MAINE TURNPIKE AUTHORITY

ADDENDUM NO. 3

CONTRACT 2021.05

YORK TOLL PLAZA DEMOLITION MILE 7.3

GENERAL NOTES 2 & EARTHWORK SUMMARY

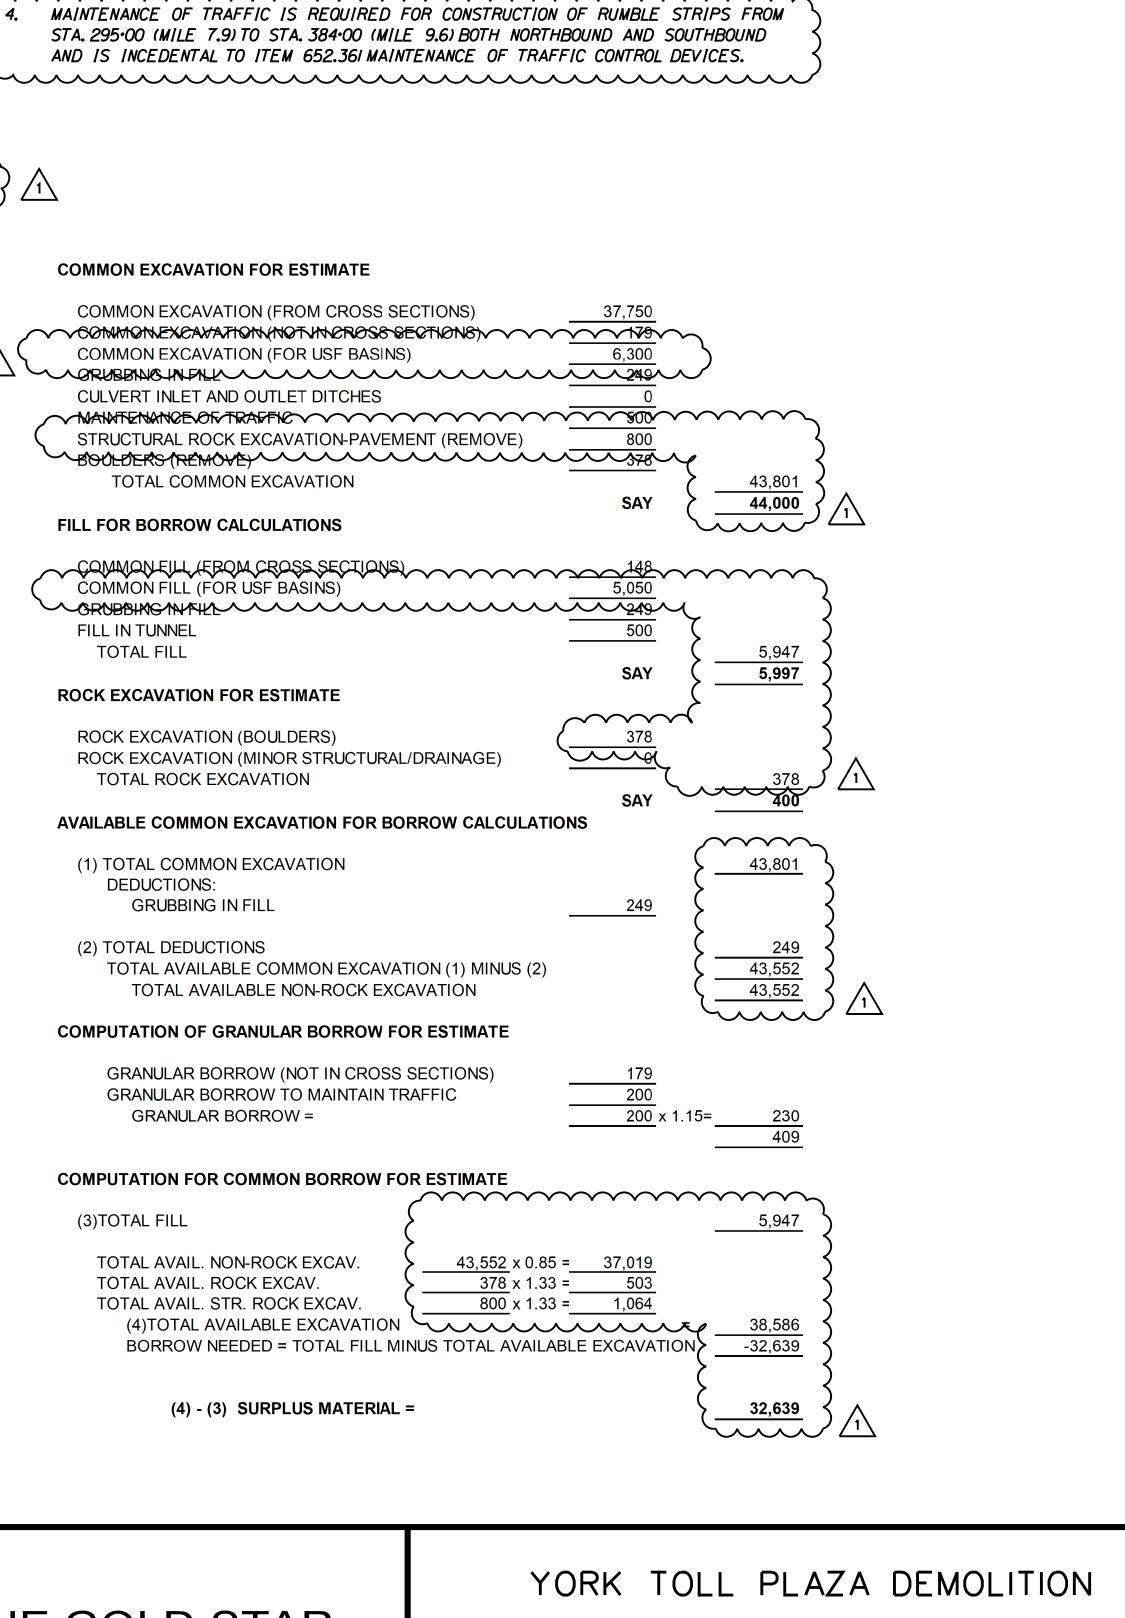
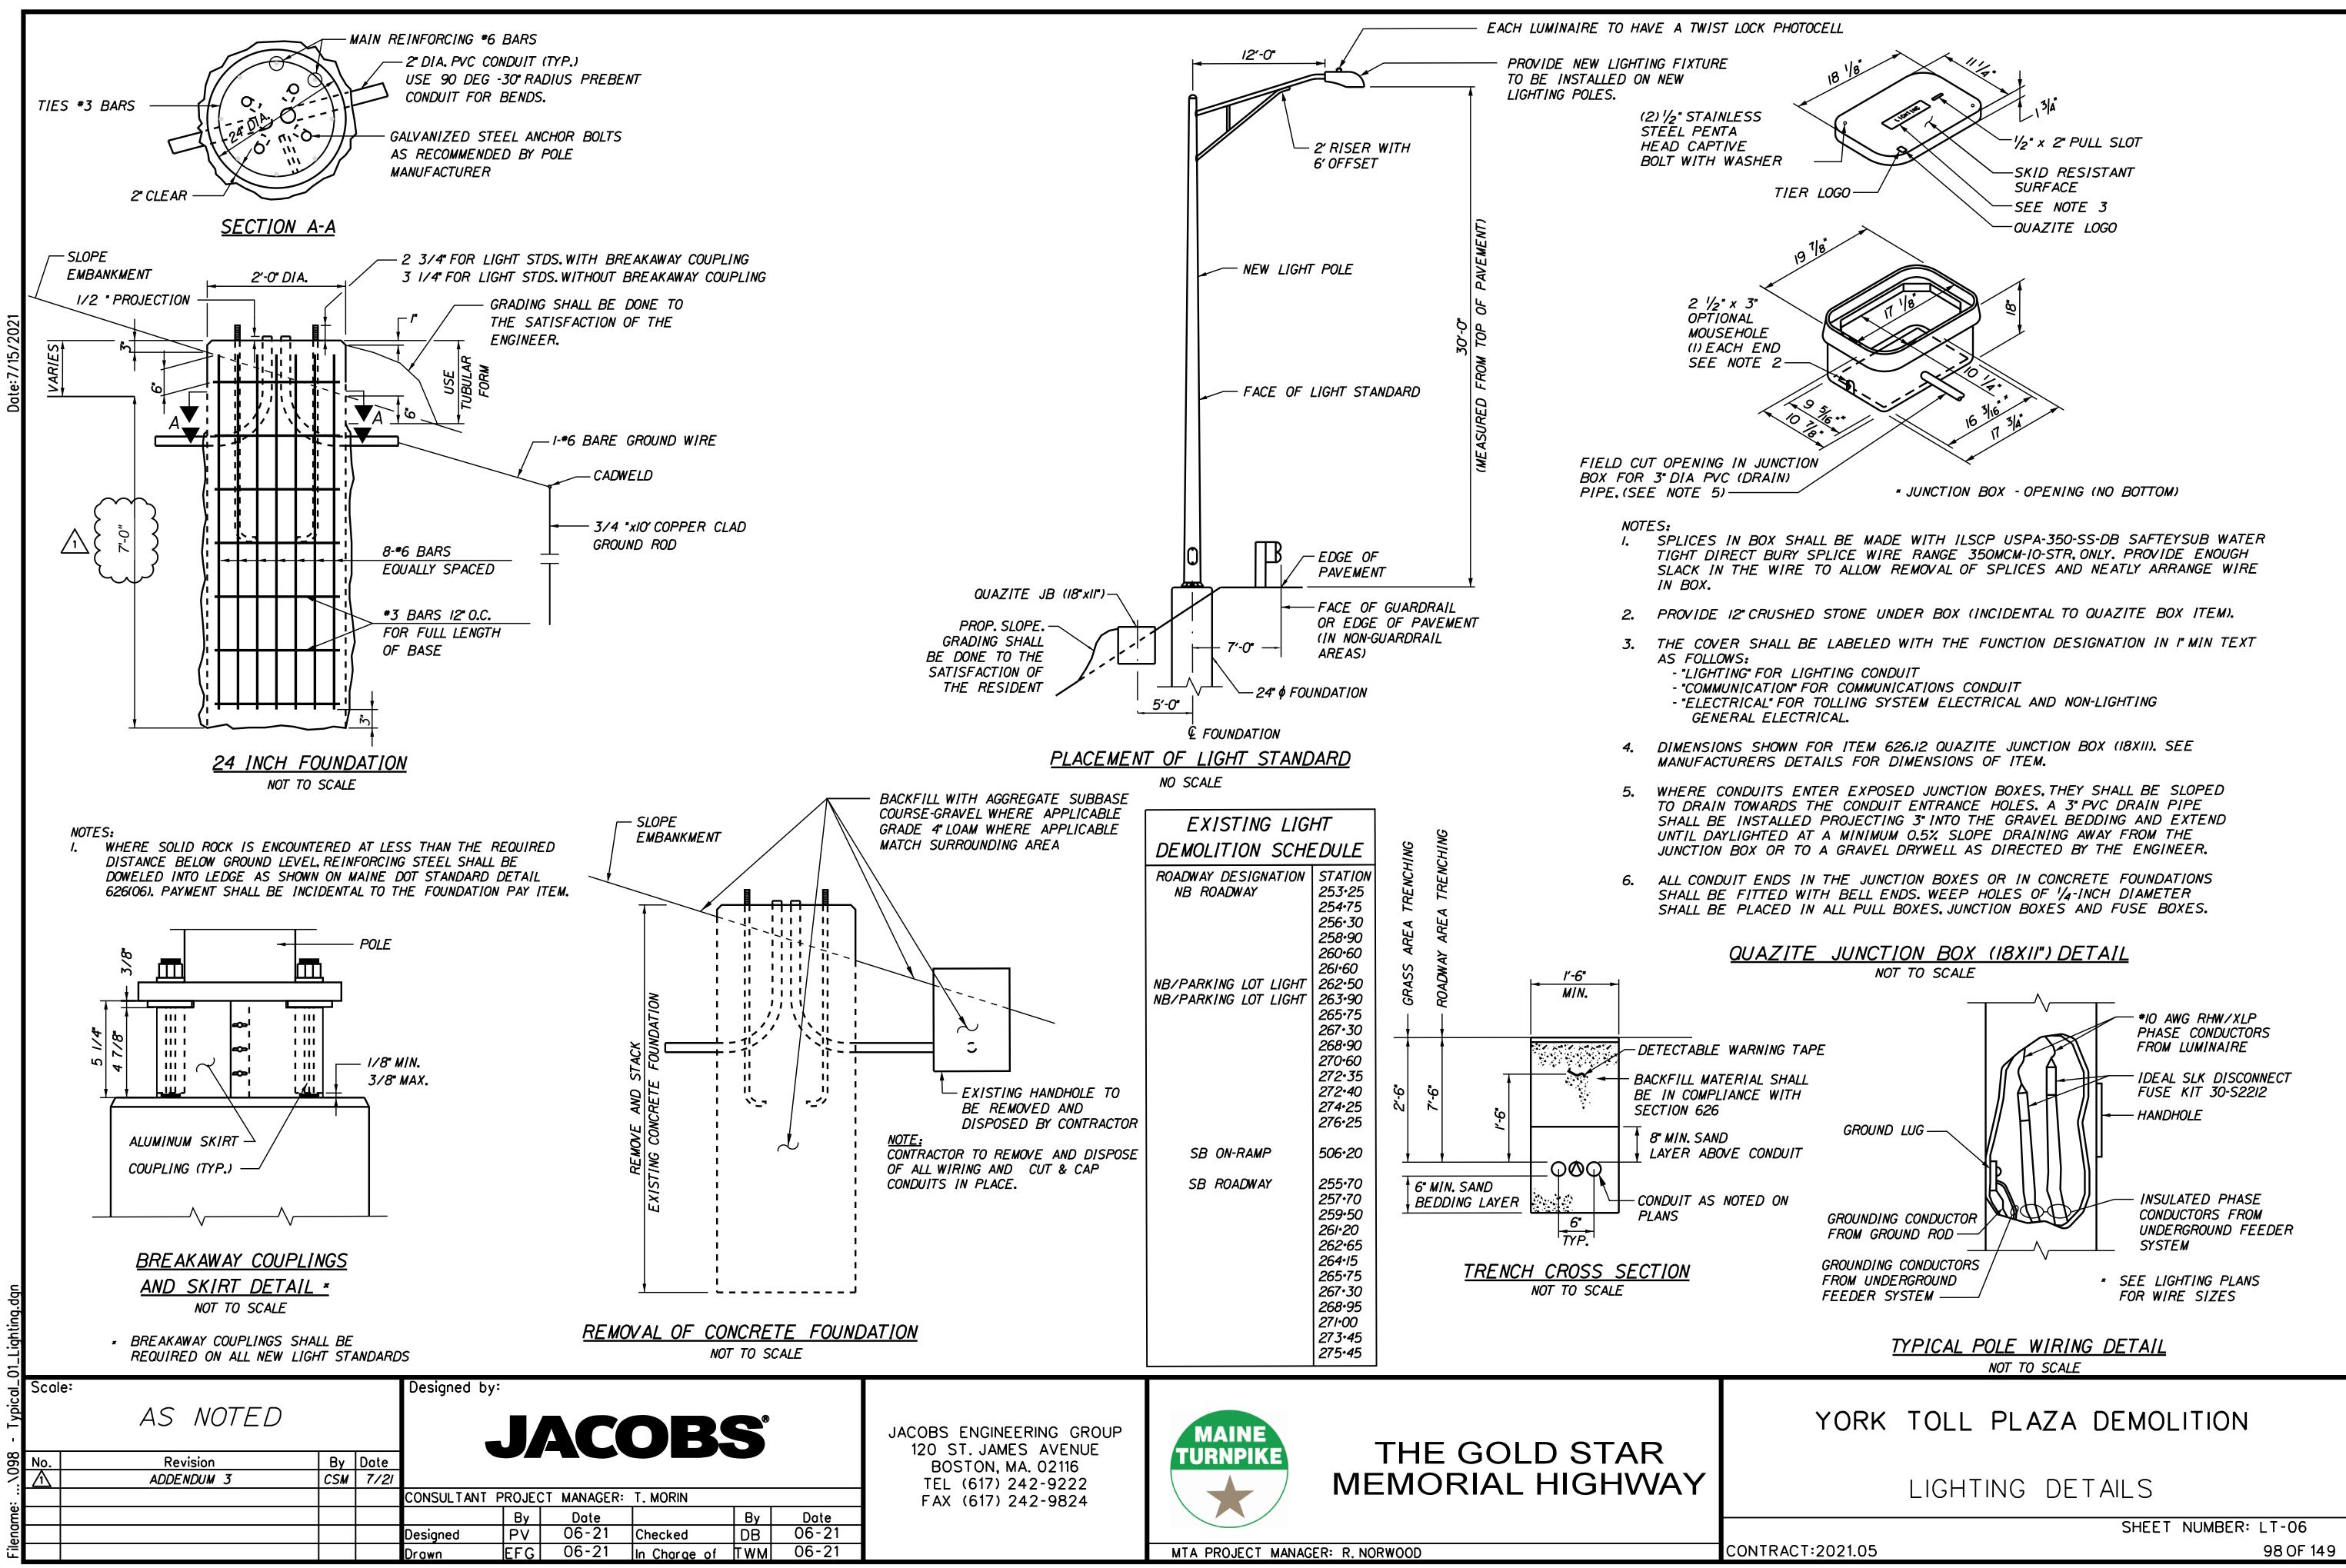
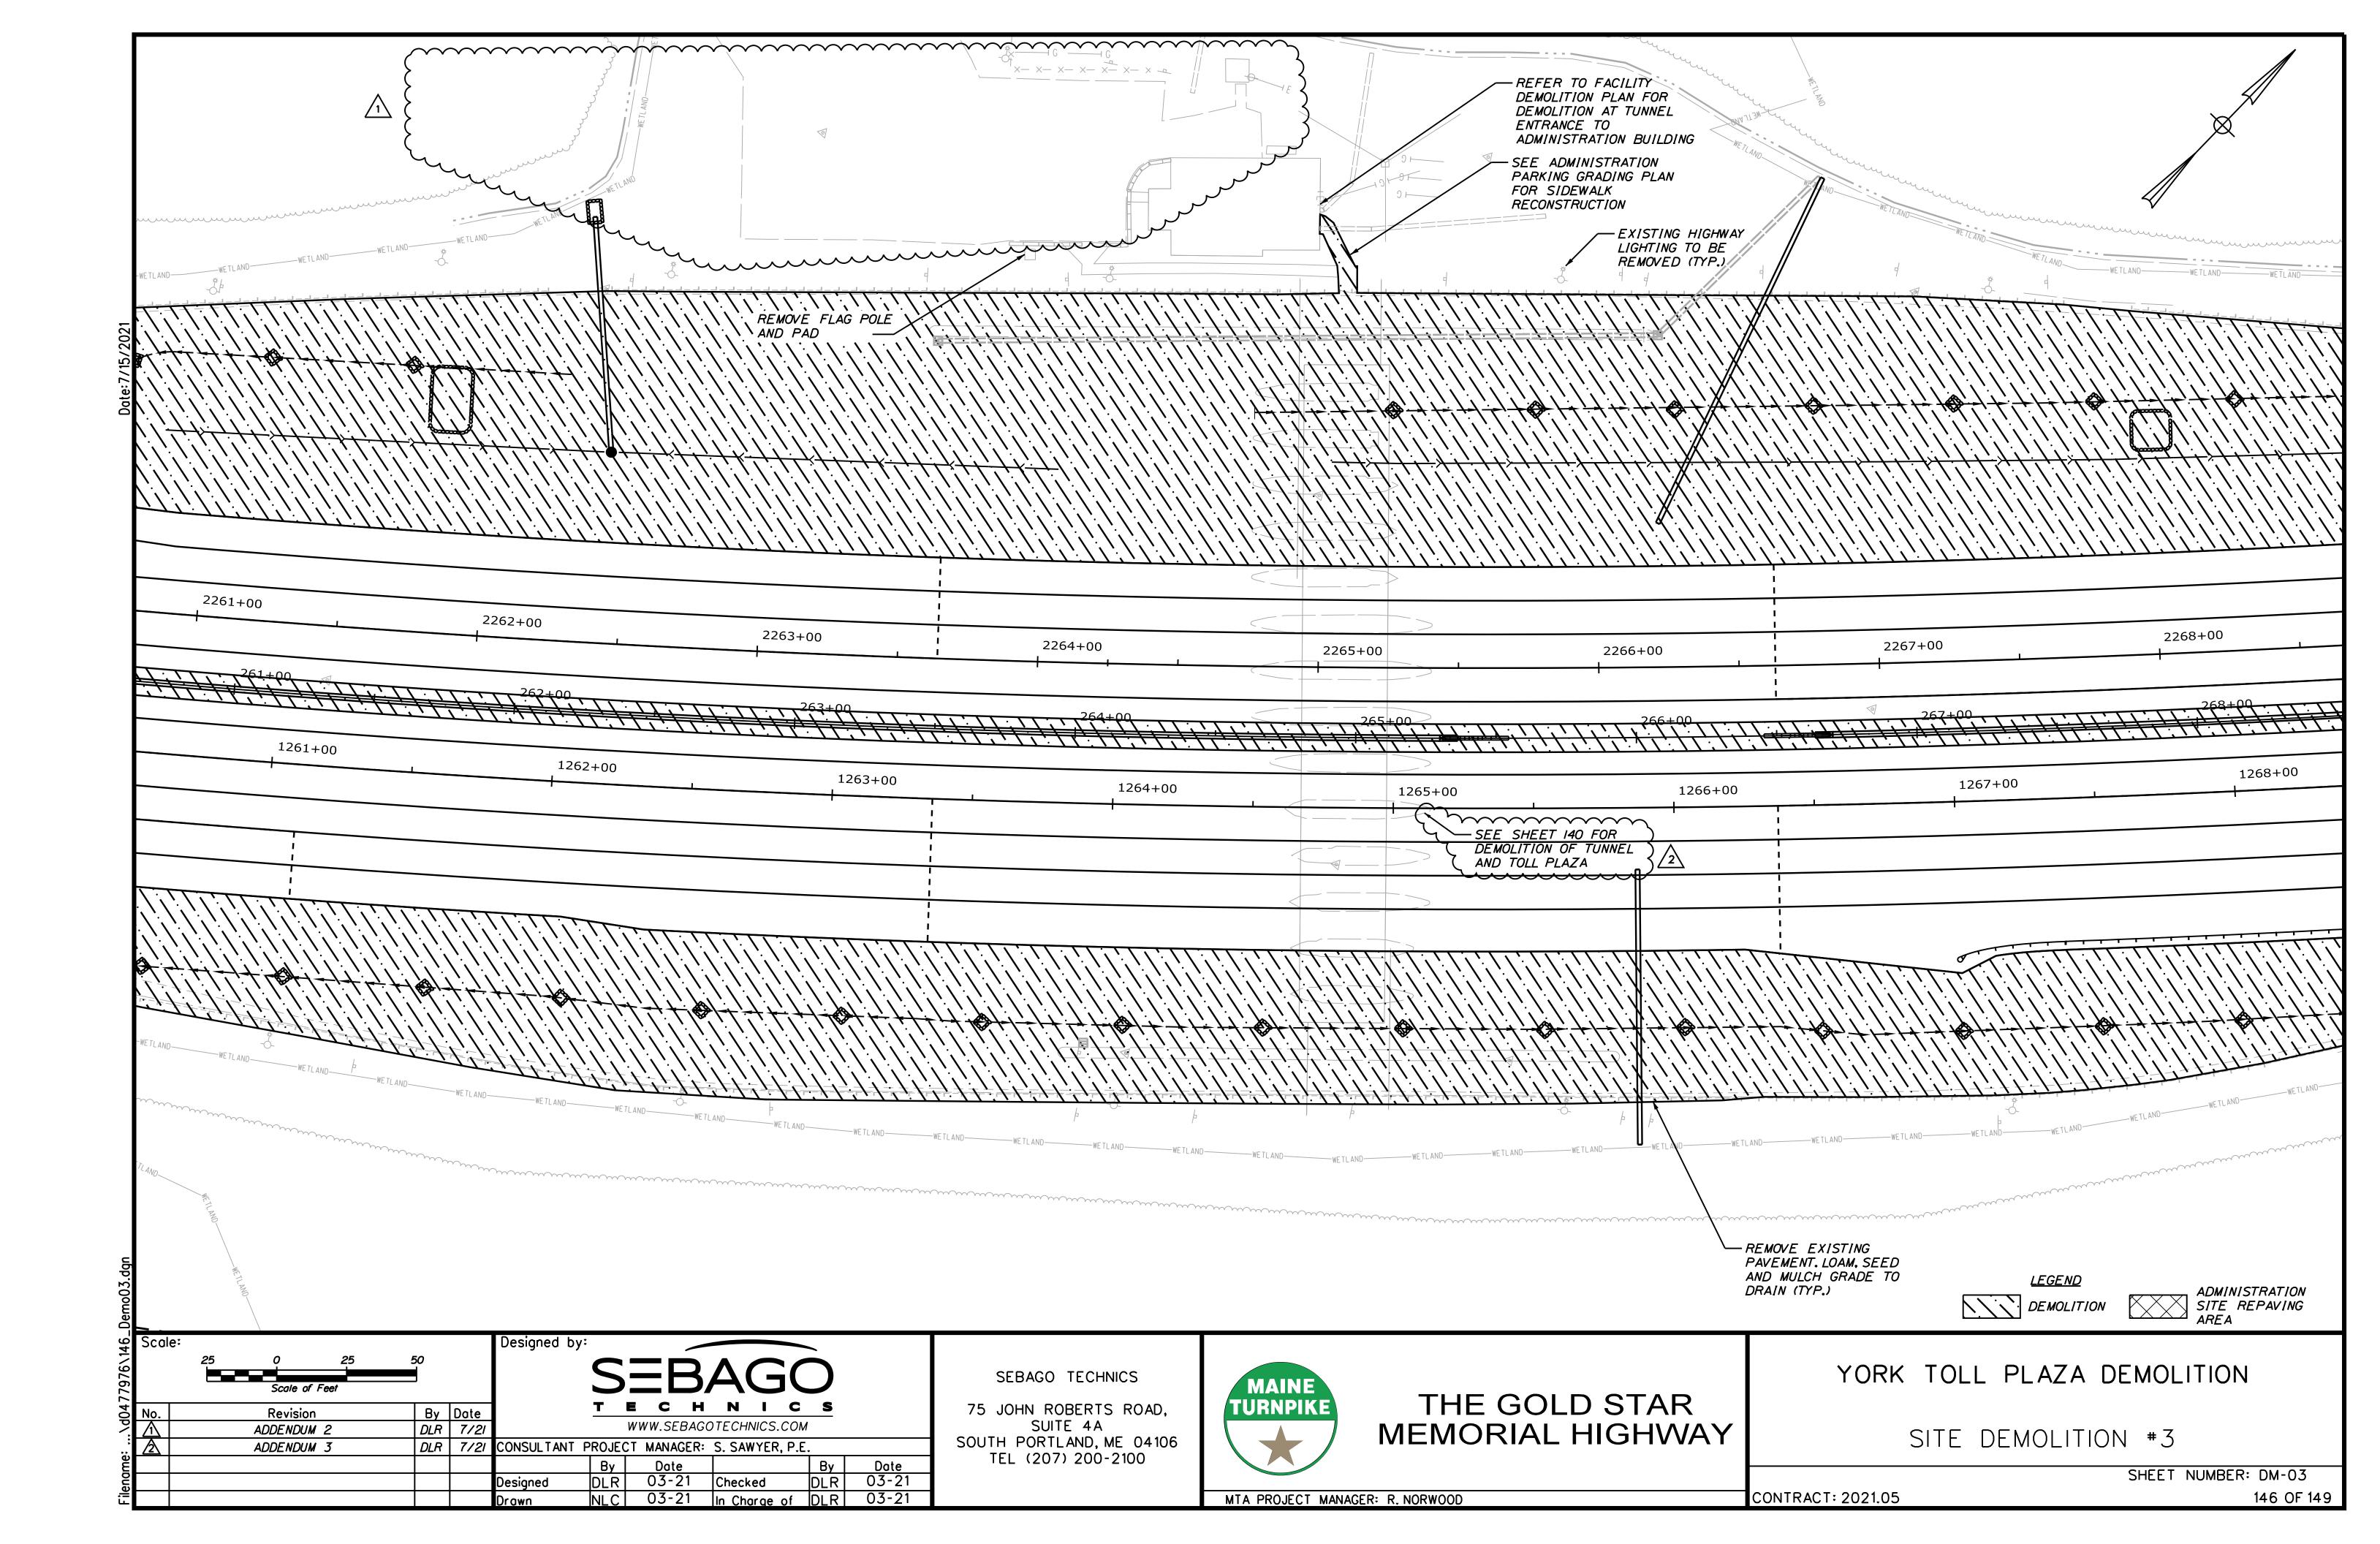
Plan Sheets 3, 5, 98, 146, all sheets are deleted and replaced in its entirety with attached revised sheets and changes noted on each sheet.
